SADLER SUBDIVISION

APPLICATION NUMBER 3 DATE December 6, 2018

REQUEST Subdivision

DETAIL SITE PLAN

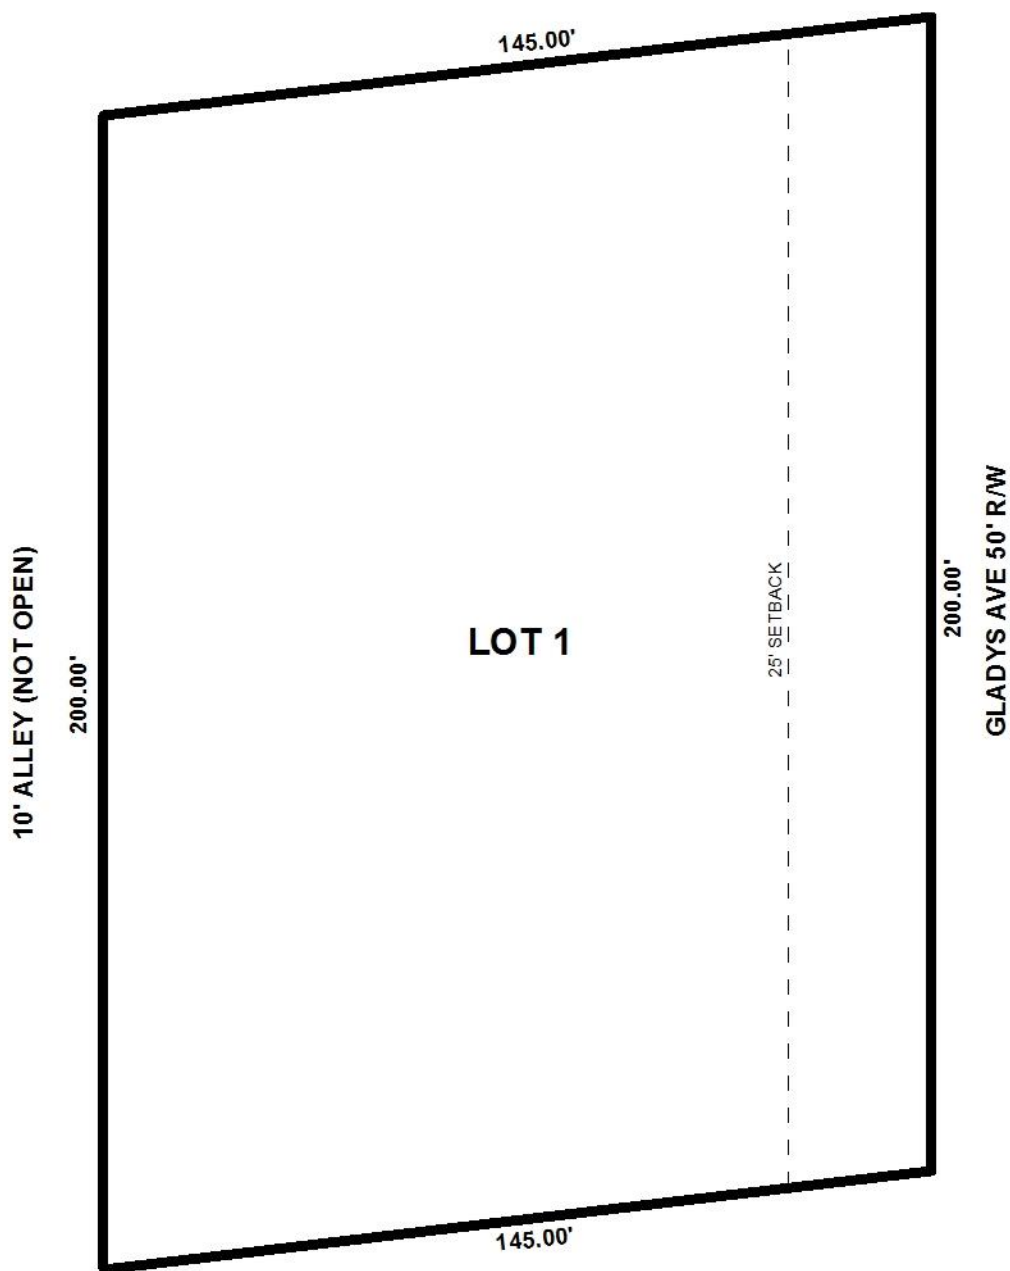
The proposed lot, which is located within the Old Dauphin Way Historic District, has frontage along Gladys Avenue, a minor street with curb and gutter requiring a 50' right-of-way, and a 10' alley with an unopened right-of-way. Adequate right-of-way is illustrated, thus no additional dedication should be required.

The lot meets the minimum size requirement for lots served by public water and sanitary sewer systems, and is appropriately labeled in square-feet and acres on the preliminary plat. This information should be retained on the Final Plat, if approved; or, provision of a table on the Final Plat providing the same information may suffice.

As a means of access management, a note should be placed on the Final Plat, if approved, stating the lot is limited to one (1) curb cut, with any changes in its/their size(s), location(s), or design(s) to be approved by Traffic Engineering and conform to AASHTO standards.

Also, per previous Subdivision Approval, a note should be placed on the Final Plat stating the lot is denied direct access to the alley.

The 25' minimum building setback line is illustrated along Gladys Avenue in compliance with Section V.D.9. of the Subdivision Regulations, and should be retained on the Final Plat, if approved; or, the applicant may request a waiver of V.D.9. in order to allow the application of the Historic District Overlay, which would allow a reduced front setback.

- 1) retention of the lot size in square feet and acres on the Final Plat, or provision of a table on the Final Plat providing the same information;
- 2) placement of a note on the Final Plat stating the lot is limited to its one curb cut, with any changes in its size, location, or design to be approved by Traffic Engineering and conform to AASHTO standards;

- 3) placement of a note on the Final Plat stating the lot is denied direct access to the alley;
- 4) depiction of a Historic District Overlay compliant minimum building setback line along Gladys Avenue;
